4F27E Ford Automatic Transmission

INSTALLATION GUIDE

Updated Rear Cover

UPDATED COOLER PORT SHOWN IN RED

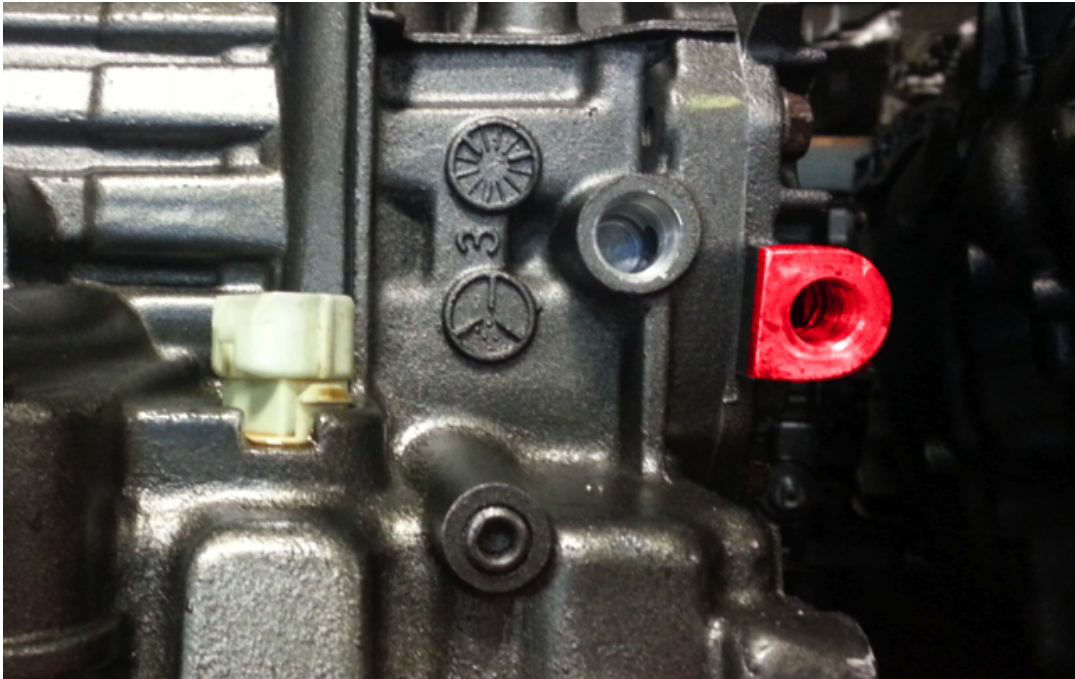
Due to premature rear cover failures in most Mazda applications, all of our remanufactured 4F27E (FN4A-EL) transmissions are updated with the improved Ford-designed rear cover.

The cooler return line must be relocated from the case to the end cover. During remanufacturing, the transmission is internally updated and the factory cooler line hole in the case is **permanently** sealed – all Ford applications will remain unmodified. Mazda units are updated to accept Mazda factory cooler line fittings (M14 x 1.50).

If you install the return cooler fitting into the original case location there will be no lubrication provided to the rear of the transaxle and immediate failure will result and is **not** covered under your warranty.
